service bulletin

M87-8

26 February 1987

SUBJECT: **EXHAUST VALVE INSPECTION**MODELS
AFFECTED: **Part I****Rebuilt Engines Only**

A

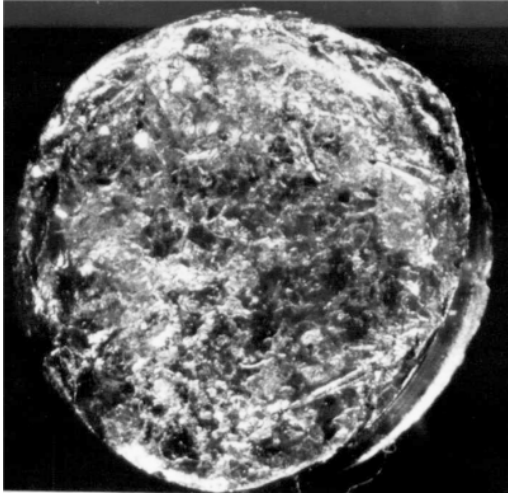
1. Remove the exhaust rocker cover.
2. Visually inspect the exhaust valve tip for abnormal wear. See Example A and B (abnormal wear).

NOTE: If wear is normal, the valve tip should appear similar to Example D (new, unused) or Example C (used, normal wear), depending on hours in use. Valves having improper hardened tips are very soft, so that abnormal wear is readily distinguishable.

3. If a valve with abnormal wear is located, please contact Teledyne Continental Motors.
4. If upon completion of the inspection or inspections explained in the COMPLIANCE REQUIREMENT section of this bulletin no valves with abnormal wear are noted, reinstall the rocker cover using a new gasket P/N 632310 and make appropriate logbook entry as to compliance with this service bulletin.
